ADDENDUM NO. 1

**CITY OF ABERDEEN
ZONE 3 ELEVATED WATER TANK
CONTRACT NO. 22-05**

City of Aberdeen
Zone 3 Elevated Water Tank Contract No. 22-05
Monday, August 28, 2023 @ 10:00 AM

Questions received through noon on 09/01/2023:

Assumed "laydown" area for bidding purpose

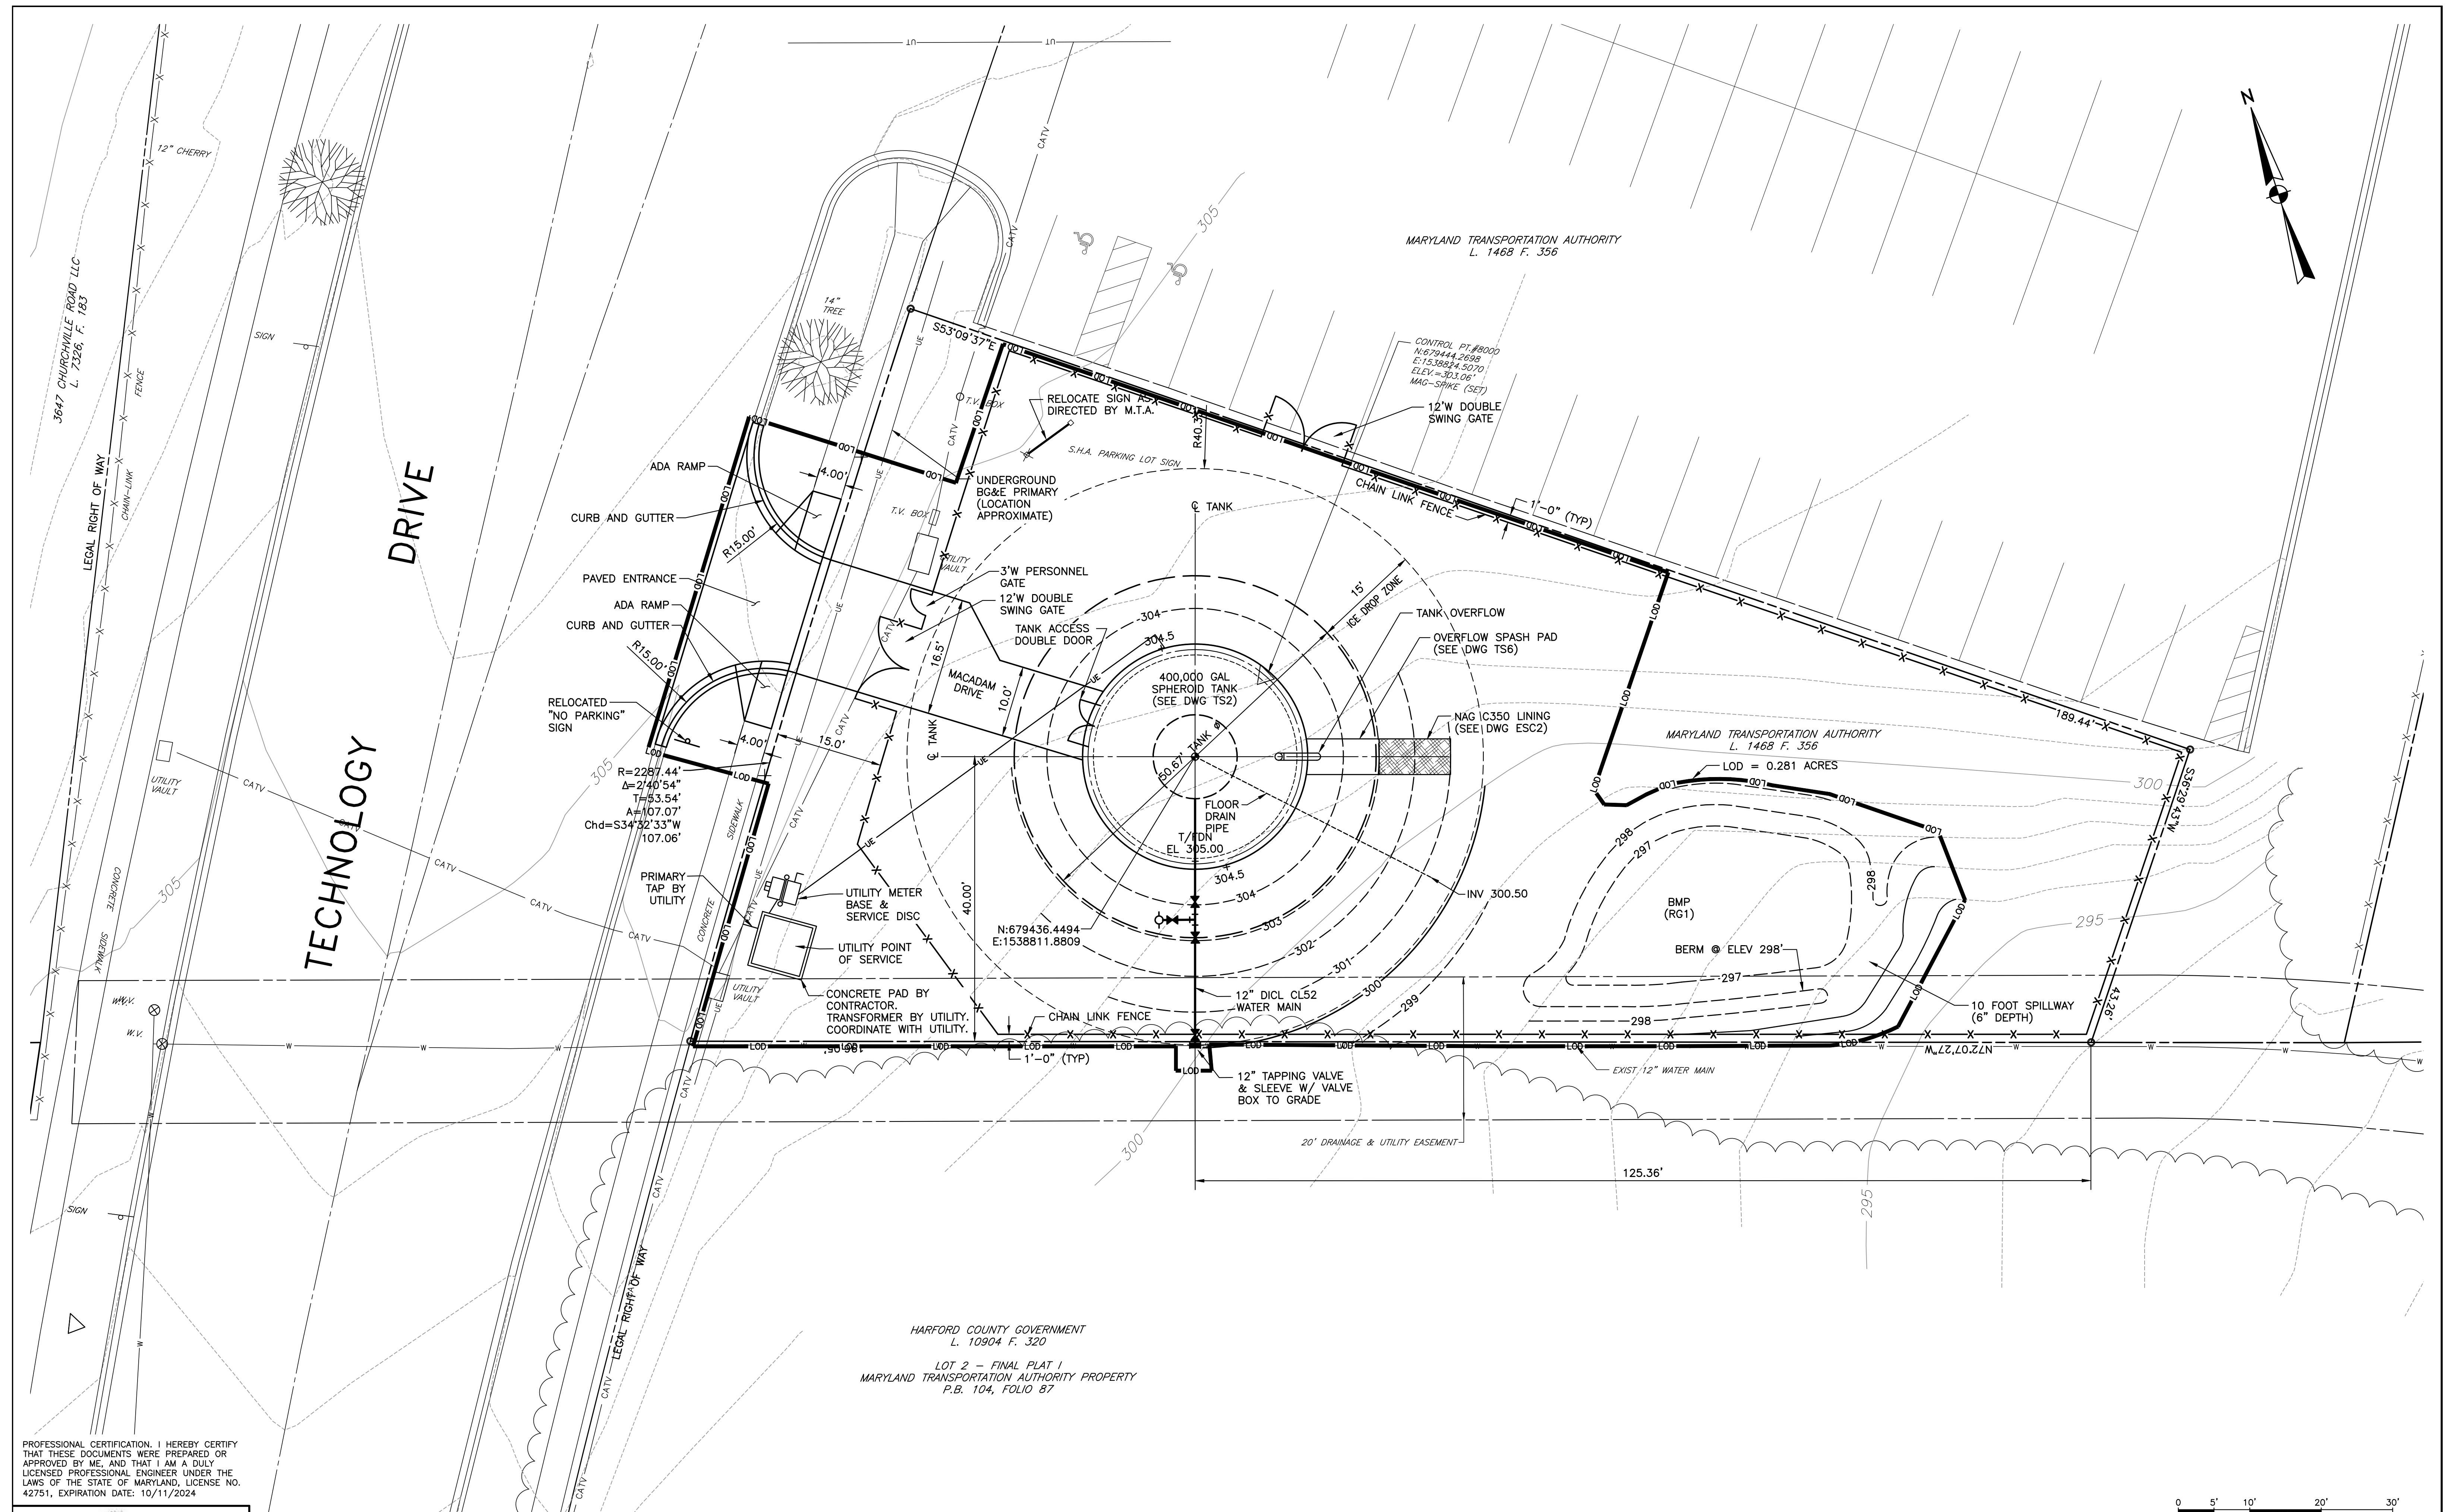
Please provide a sketch showing the Work Area that all bidders should assume will be made available to us in the parking lot. I.e. the first three (3) rows, with the Bidder being only responsible for temporary fencing (and not damage to the existing asphalt surface, etc.)

A sketch of the assumed for bidding purpose "laydown" area is provided as part of Addendum No.1. Also refer to Question No.22.
